REMARKS

ANNOTATED MARKED-UP DRAWINGS
Serial No.: 10/611,595

FIG. 1 RED-marked
COPY

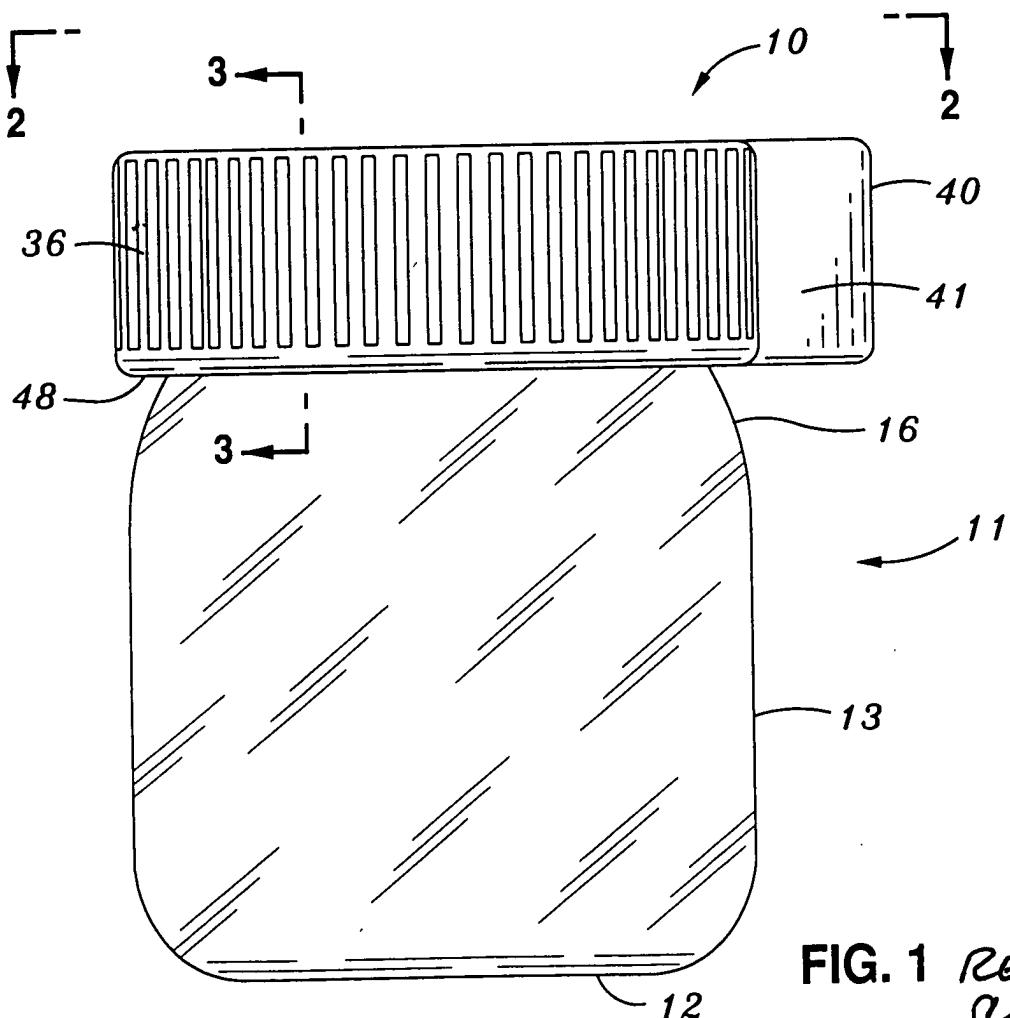
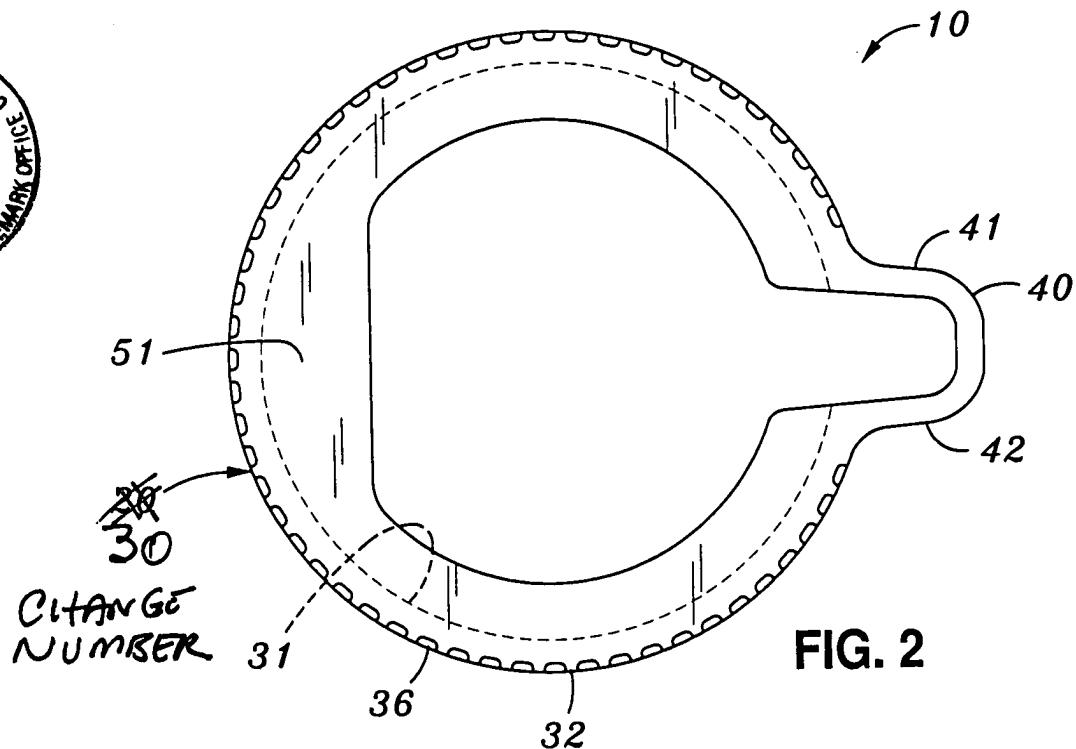
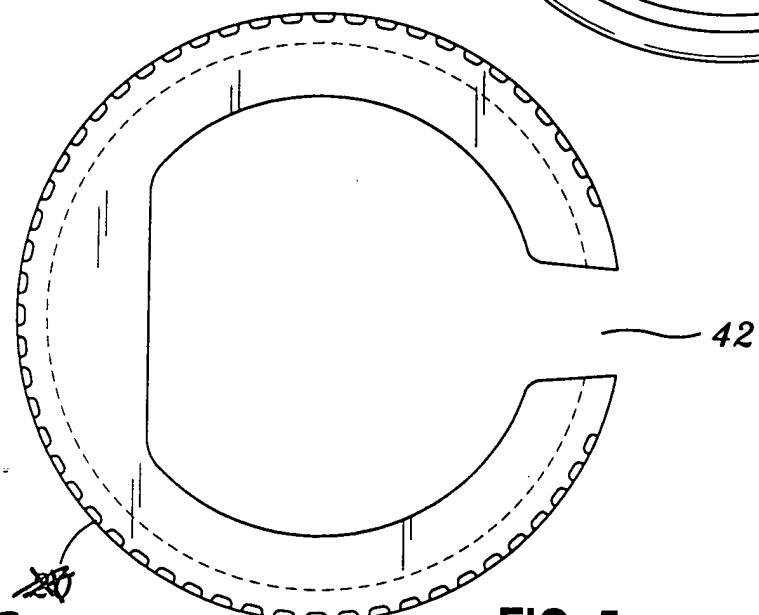
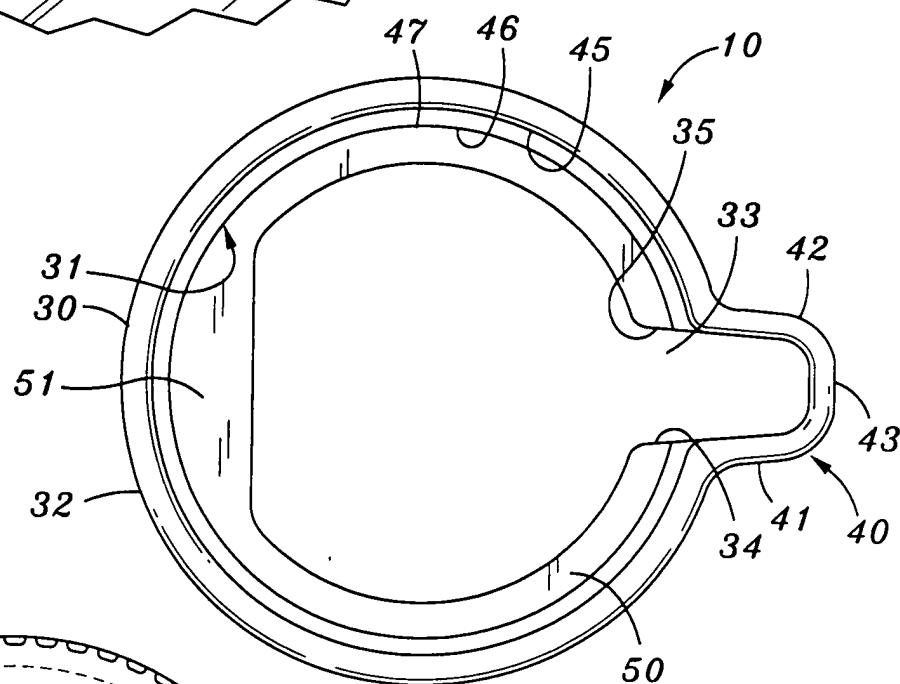
In the drawings, reference number 20 in Figs. 1 and 5 has been corrected to "30". Substitute sheets are enclosed, and a set marked in red is enclosed. The Examiner is requested to approve these changes.
